Access Compliance Report Public Rights-of-Way (Pedestrian Signals)

Main Street: **VILLA_PARK_RD** Cross Street: **VILLA_PARK_RD** Location: **NW**

ADA ID: **SGRK211222140737** Signal Type: **One Push Button-Non APS** Overall Compliance: **No** Severity Scores: **BTN 1: 60** **BTN 2: N/A** **No BTN: N/A**

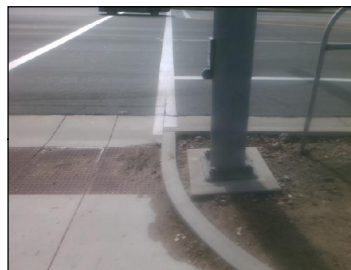
Surveyor Notes: N/A

Possible Solutions: Replace Signal Push Button With APS Button. Provide Push Button Extension. Remove and Replace Clear Space.
